SUBJECT: REQUESTS LICENSE AMEND TO ALLOW SMALL POSITIVE MODERATOR
 TEMP COEFFICIENT DURING REACTOR STARTUP & VARIOUS
 ADMINISTRATIVE CHANGES. FORWARDS PROPOSED REVISIONS TO TECH
 SPECS, SUPPORTING ANALYSIS & \$5,200 AMEND FEE.

FILE: NG-3514(R)

H. B. ROBINSON STEAM ELECTRIC PLANT, UNIT NO. 2
DOCKET NO. 50-261
LICENSE NO. DPR-23
LICENSE AMENDMENT TO ALLOW A SMALL POSITIVE
MODERATOR TEMPERATURE COEFFICIENT AND VARIOUS ADMINISTRATIVE CHANGES

Figure 3.10-2 SHUTDOWN MARGIN VS BORON CONCENTRATION

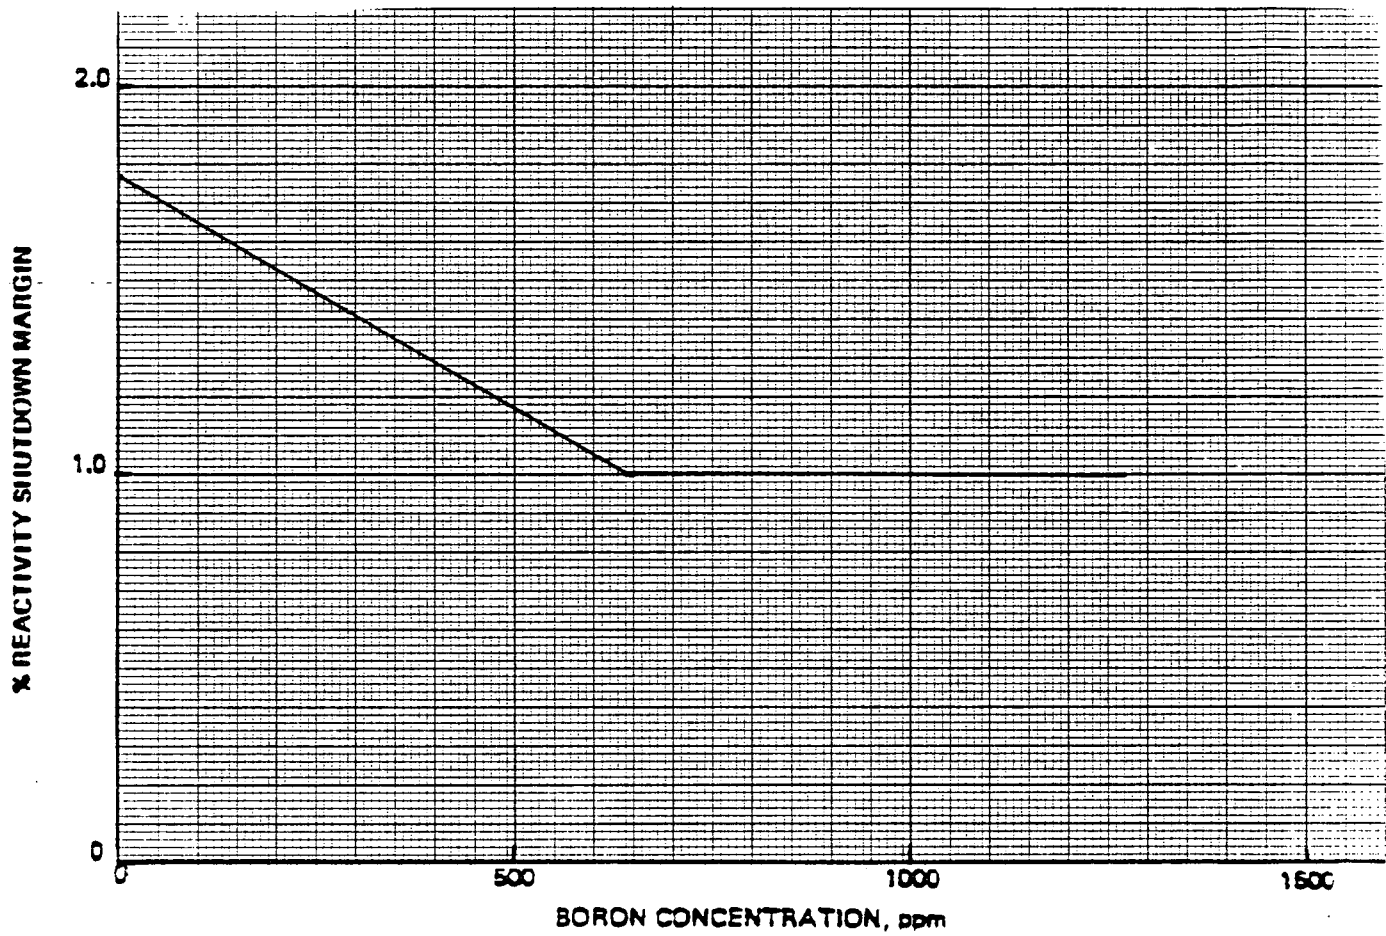
The other attached changes are administrative in nature. They delete references to early cycle requirements, correct figures or clarify wording. The change to Figure 3.10-2 changes the Zero Boron Shutdown Margin to 1.77. This is the number that was actually used in the Safety Analysis, and the graph is being changed to conform with it.
